Informative Back Plane Channel: Ad-hoc Recommendations

Abstract: This presentation covers the conference calls and work of the channel ad-hoc group between the March 2004 meeting and the May 2004 meeting, as well as recommendations for a starting point on how the 802.3ap working group should define an informative channel model.

SDD21 Channel Magnitude Mask

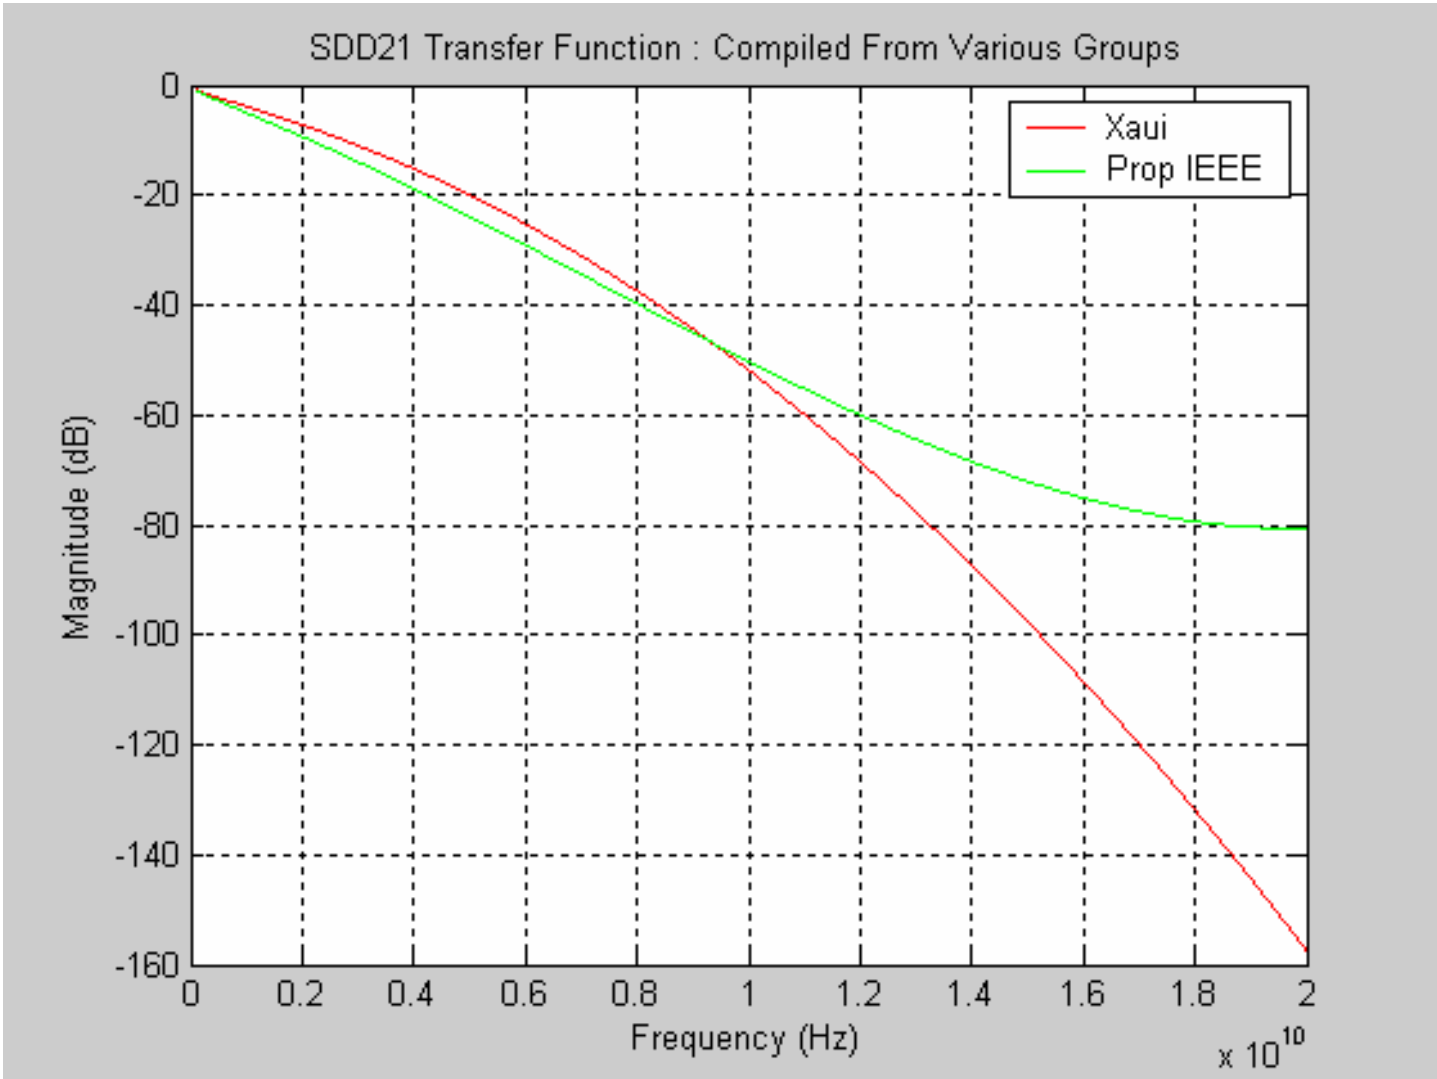
- Consensus to use Joel Goergen's equation and constants contribution to the ad-hoc for the SDD21 Magnitude Mask.
- Consensus to use CX-4 Return Loss Equations defined in 54.7.3 as SDD11 and SDD22 Magnitude Masks.

- $b1 = 6.5E-06$
- $b2 = 3.3E-10$
- $b3 = 3.2E-20$
- $b4 = 1.38E-30$
- $SDD21 = -20 \cdot \log_{10}(e) \cdot (b1 \cdot \sqrt{f}) + b2 \cdot f + b3 \cdot f^2 - b4 \cdot f^3$

SDD11 and SDD22 Channel Magnitude Mask

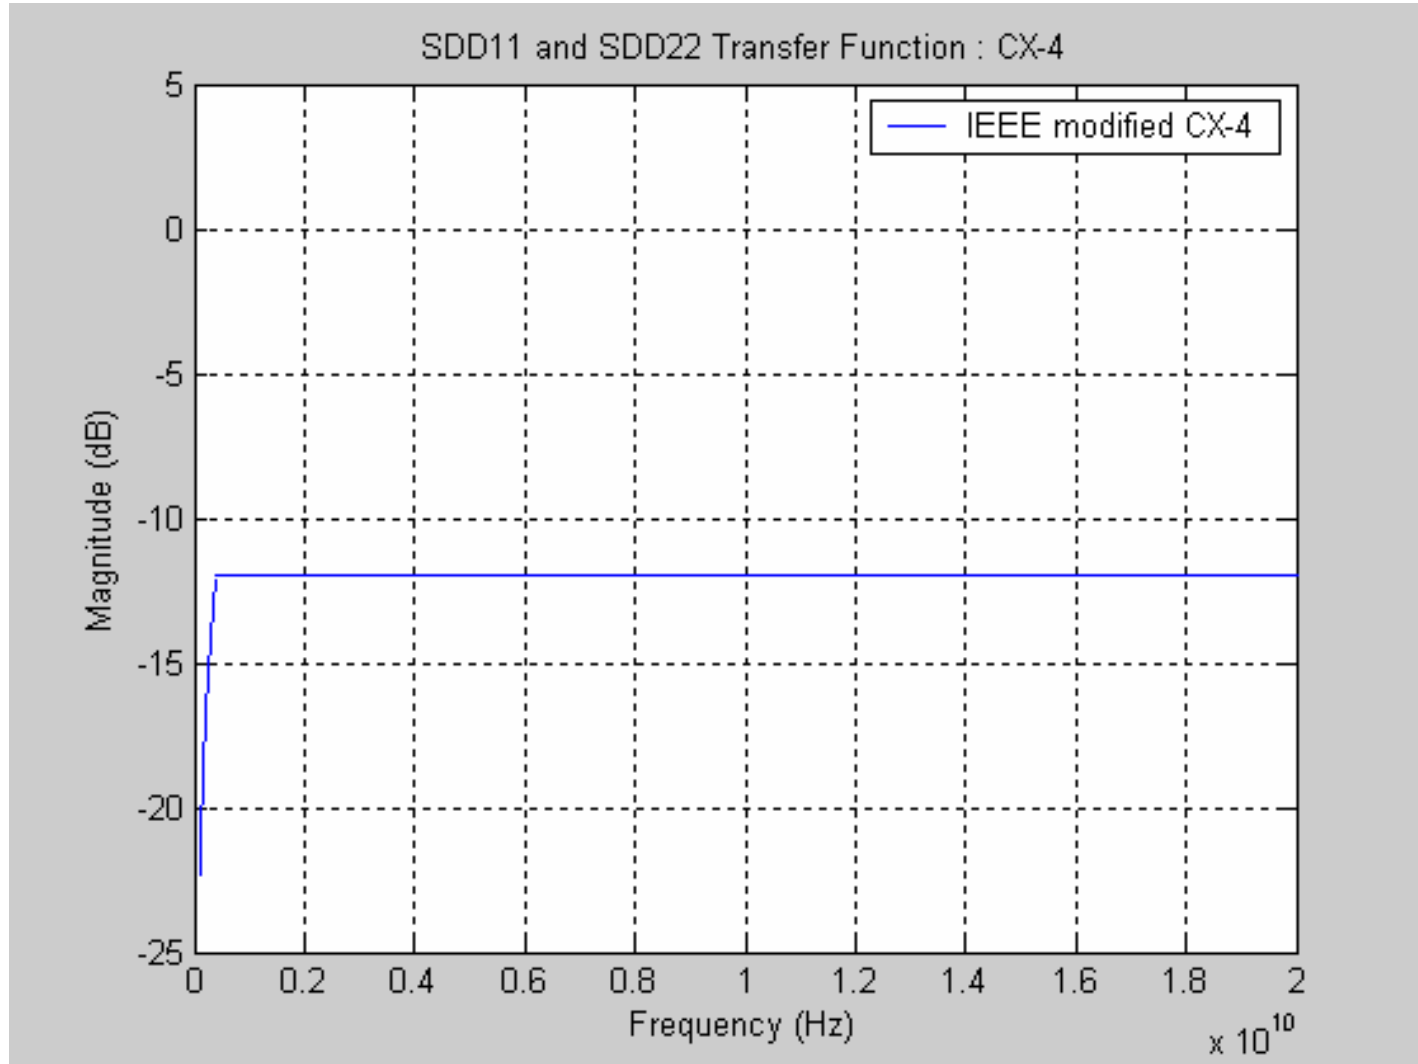
- ◆ There was considerable confusion with both SDD11 and SDD22 return loss defined in 54.6.3.5 from the transmitter and receiver point of view with the SDD11 and SDD22 defined in 54.7.3 from the channel point of view.

- ◆ I believe most of us were thinking of the channel.
 - ◆ Zhi Wong's contribution on this matter referred to the silicon. His presentation points out the defined CX-4 equation crosses the 0dB line at 5Ghz. This will need to be addressed if these equations are used for a baseline from the silicon point of view.

- $\text{ReturnLoss}(f) \geq 22.35 - 17.19 \times \log(f/100)$, f in Mhz
 - ◆ For $100\text{Mhz} \leq f < 400\text{Mhz}$
- $\text{ReturnLoss}(f) \geq 12$
 - ◆ For $400\text{Mhz} \leq f \leq 20000\text{Mhz}$

NEXT/FEXT Channel Magnitude Mask

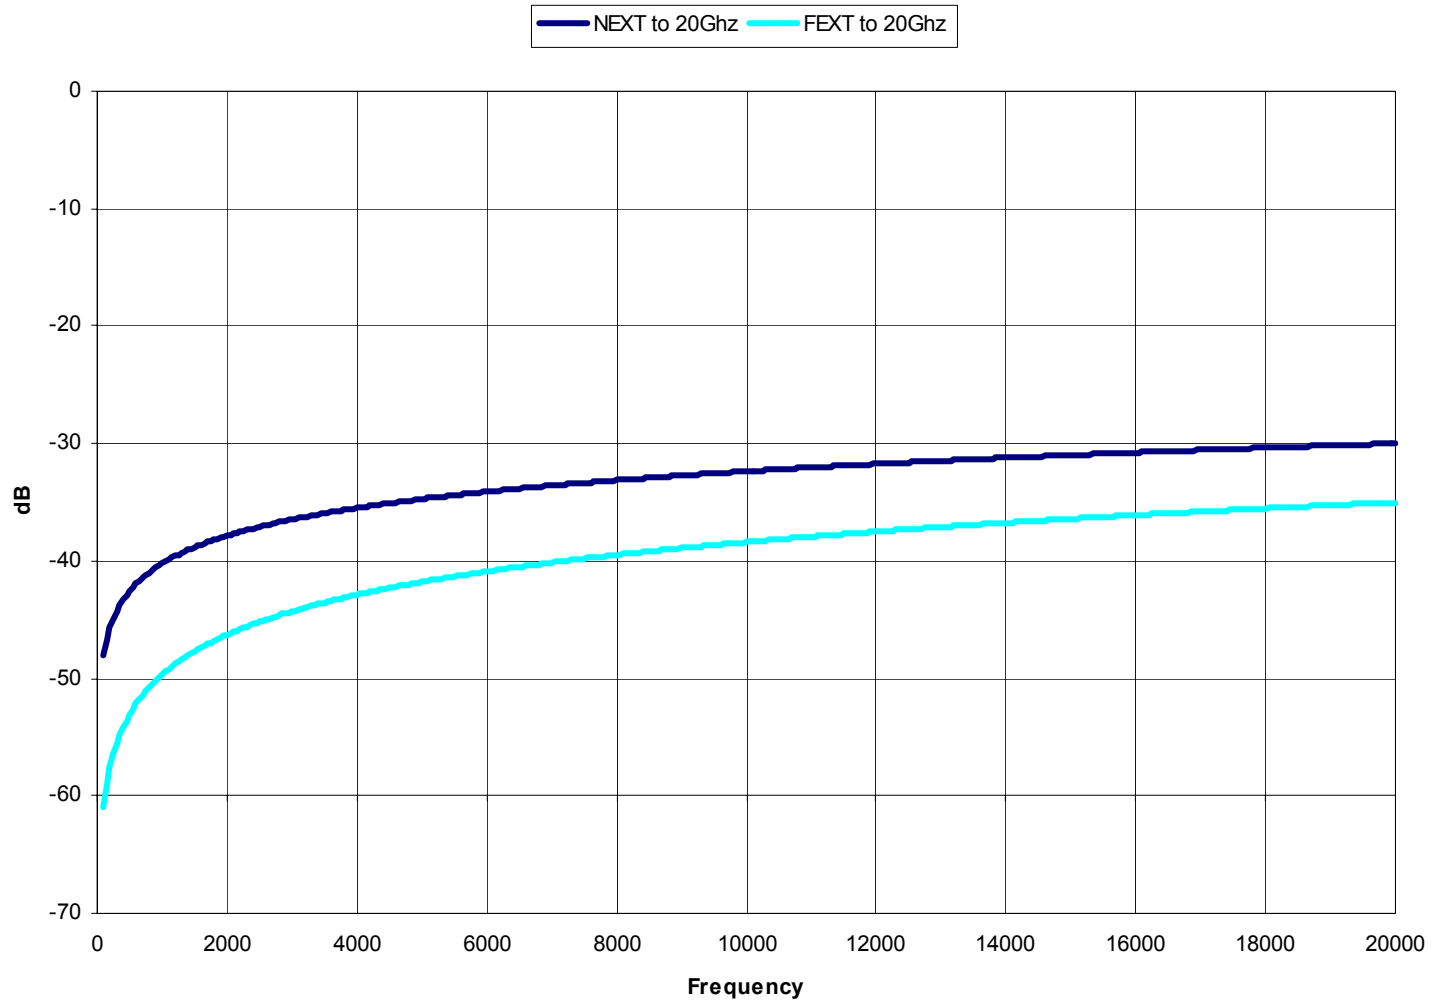
- Consensus to use CX-4 NEXT Equations defined in 54.7.4 extrapolated to 20Ghz and lowered by 10dB as NEXT Magnitude Mask, based on contributions from Jeff Cain and Joel Goergen.

- Consensus to use CX-4 FEXT Equations defined in 54.7.5 extrapolated to 20Ghz and lowered by 10dB as FEXT Magnitude Mask, based on contributions from Jeff Cain and Joel Goergen.

- Verify known channels meeting 'Improved FR-4' material guidelines to SDD21, SDD11, and SDD22 proposed masks.
- Verify NEXT and FEXT masks. CX-4 shows FEXT with a higher limit than NEXT. We need to address why that was originally done.
- Verify Group Delay mask concept and gather data to support it.
- Devote at least one call to the effects temperature and humidity have on 'Improved FR-4' and the proposed six masks.
- Devote at least one call to the effects packaging will have on the proposed six masks.
- Develop and distribute a test and measurement board that meets close to the worst case of each mask, as well as the best cases possible. The intent is to establish confidence in presented data across presenters and various measurement equipment / techniques.

- NEXT to 20Ghz = $30 - 7.85 * \text{LOG}(f/20000)$; f in MHz
- FEXT to 20Ghz = $35 - 11.27 * \text{LOG}(f/20000)$; f in MHz

Group Delay Mask

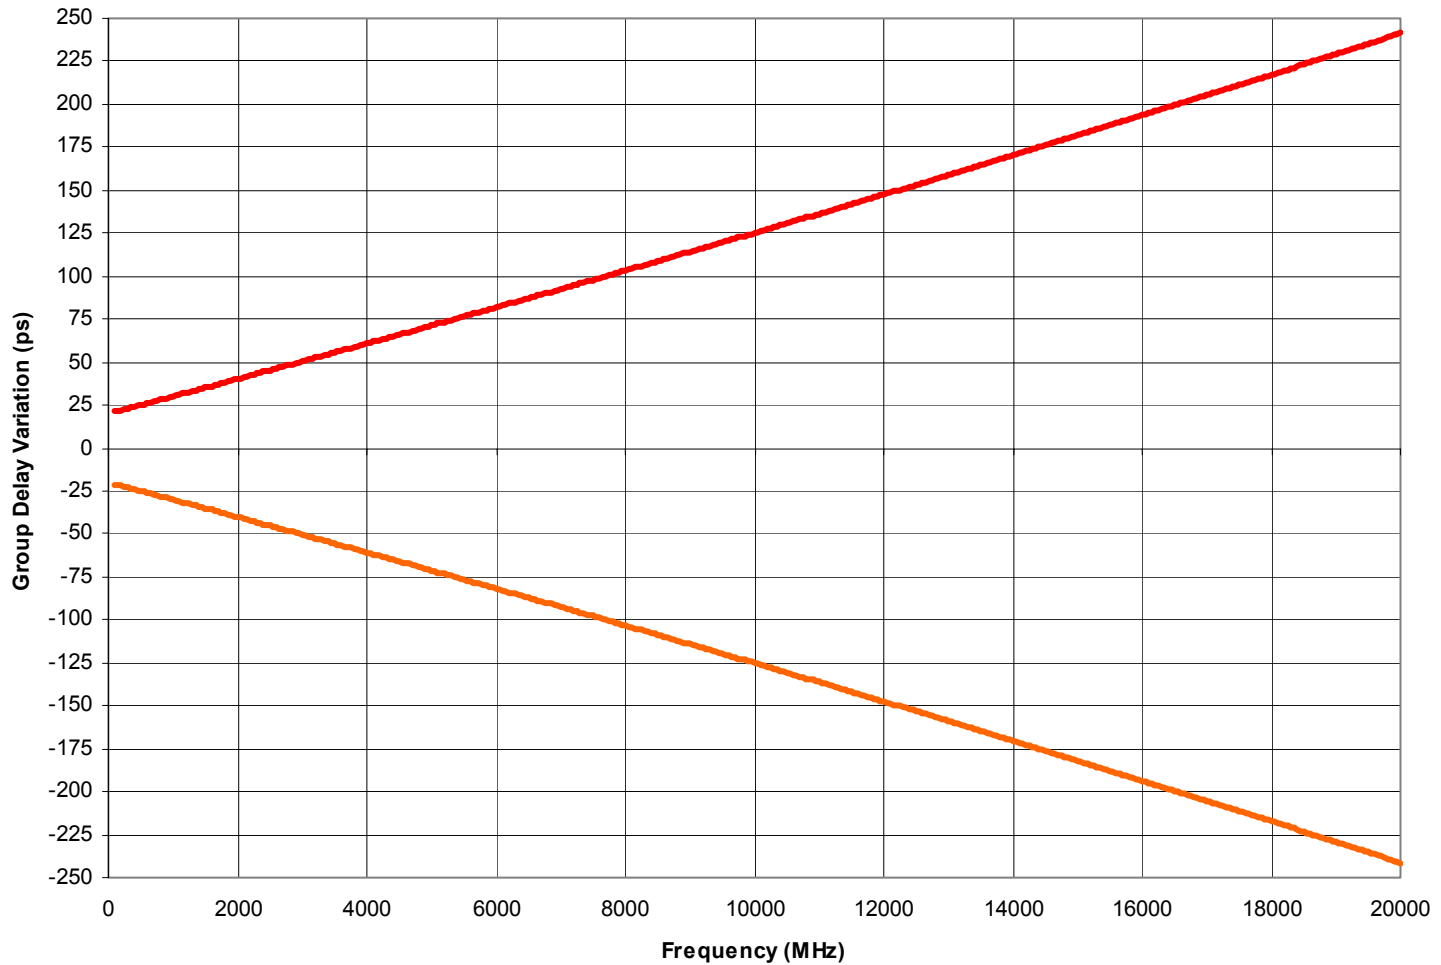
- Consensus to use Jeff Cain's group delay contribution, but change the curve y-axis label to 'Group Delay Variation' and normalize it about zero as the Group Delay Mask.

- Top Slope = $1000 * (\text{EXP}(f/1000000) - 0.98)$; in ps
- Bottom Slope = $-1000 * (\text{EXP}(-f/1000000) - 0.98)$; in ps
 - ◆ Bottom Slope based on $1000 * (\text{EXP}(-f/1000000) - 1.02)$ and modified as above for symmetry.
